Interactive comment on “Regional GRACE-based estimates of water mass variations over Australia: validation and interpretation” by L. Seoane et al.

Final Authors Comments.

Anonymous Referee 1

Fig. 1. Australian drainage regions used in our study. Geographical locations of the bores in the Murray–Darling are marked as black circles.

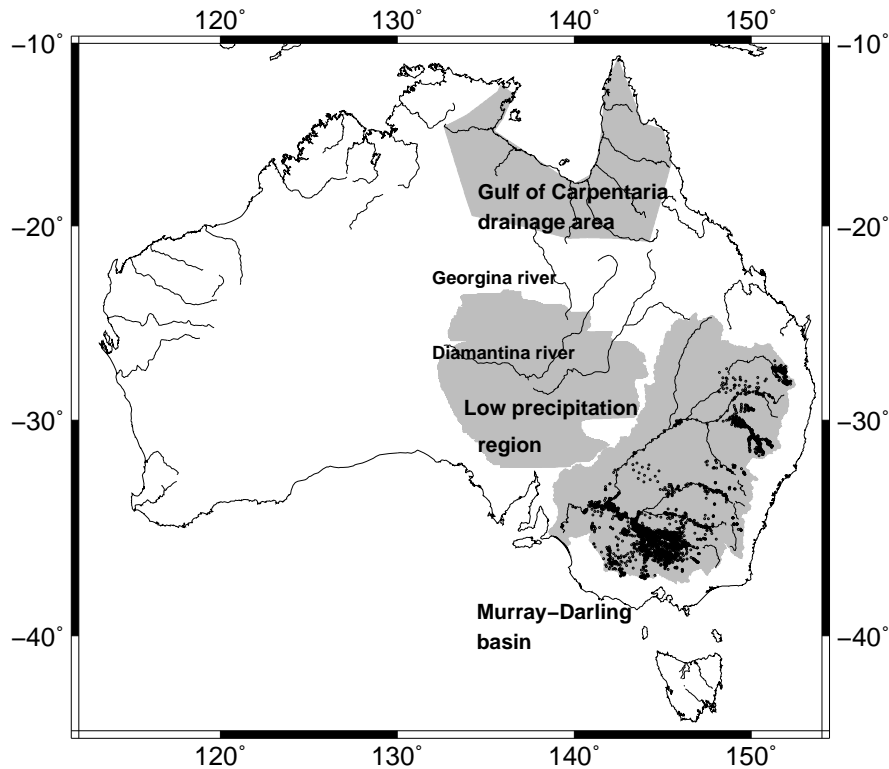
Similarly, Figure 4 would deserve some improvement. Could you show the “central desert” region on Figure 1. The way Figure 4 (fig 5 in the new version) is plotted may look suspicious. Why don’t you show the whole time period? From the rainfall data, 2006.5 to 2006.9 is even dryer than the selected period, and there might be dryer periods throughout the period of interest (2003- 2011). This whole discussion on the Australian climatic settings and how they are captured by GRACE solutions could also be sent to the results and discussion part.

During the dry periods in the part of the central desert (e.g this region shown in Fig. 1 is estimated in base on the level of rainfall over six consecutive months which remains less than 30mm every month; see Fig. 5a for time periods). As the expected values of mass variations due to hydrology in this area should be small for these periods, then the recovered TWS amplitudes can be also considered as an indicator of the level of uncertainty on our prediction. For GRACE-based solutions, Fig. 5b reveals standard deviation values of 12-19 mm of EWH. Low value of 12 mm for ICA filtered solution are due to resulted smooth signal. Estimated values of regional and global GRGS solutions are close, 19.11 and 16.3 mm respectively.

Fig. 2. Water mass time series averaged over Australia: (a) difference between regional and GRGS solutions, (b) GRGS GRACE solutions up to degree 6, and (c) their difference

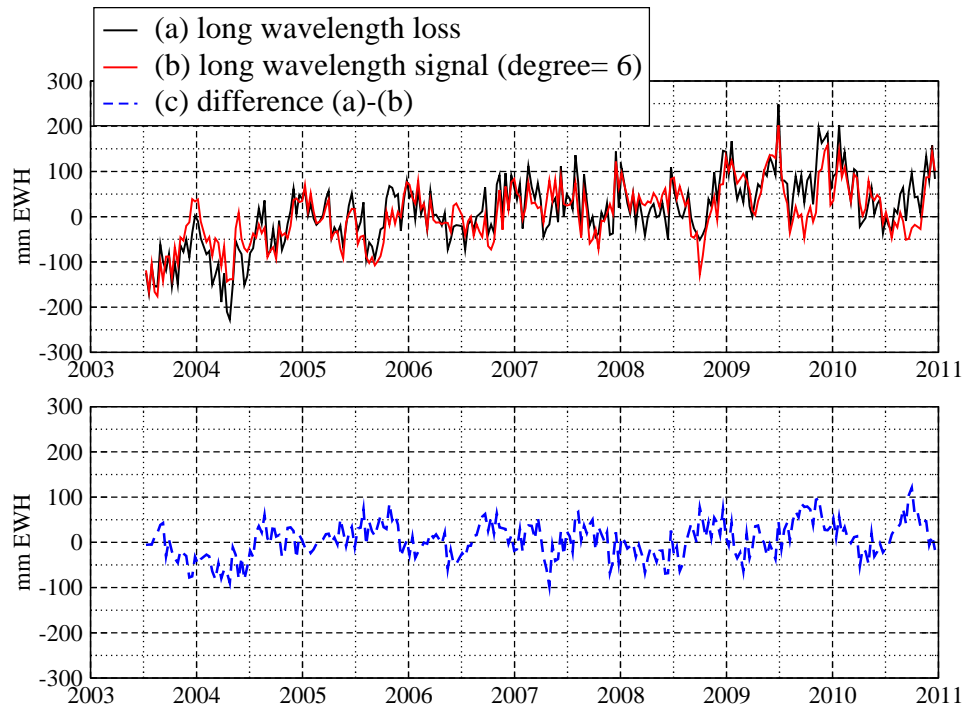
4) Page 5359 Figure 2 is very difficult to read, but of major interest

We have changed the figure 2.

Fig. 3. Time series of regional maps of water mass from December 2008 to November 2009. We can notice the annual signal with amplitude of 250 mm of EWH representing the alternating wet and dry seasons.

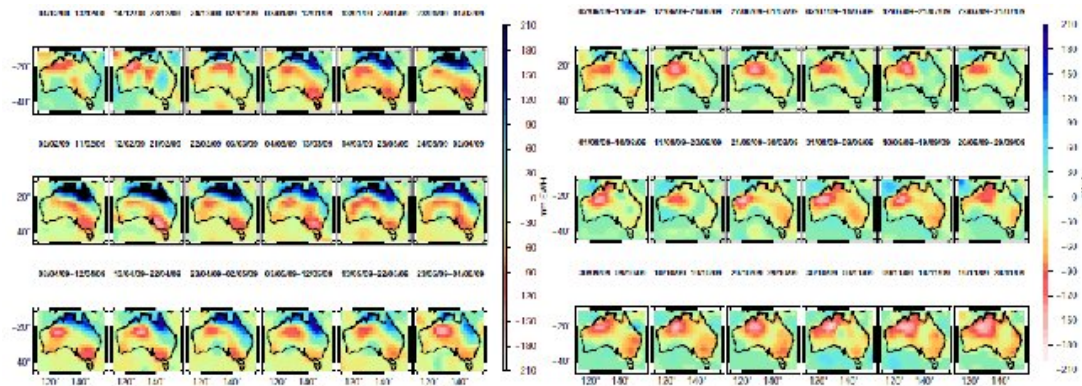
5) Page 5360 Line 28 and around. Figure 3 is very difficult to read. Showing maps of trends and amplitude of seasonal cycle would support the interpretation made in this section.

We have added new figures (now figures 4 a and b)

Additionally, we show in Fig. 4 the maps of linear trends and annual amplitudes computed over 2003-2009. Even if the long term variations over Australia are not strictly linear, the trends reveal the regions where the most important mass losses occur for 2003-2009 (period of el Nino influence ; we avoid la Nina influence period 2009-2011), as Murray-Darling basin and the Sandy desert, or mass gain, as around the Canning basin (Northwest of Australia) in the last years. The mean annual amplitudes are maximum at the tropical area.
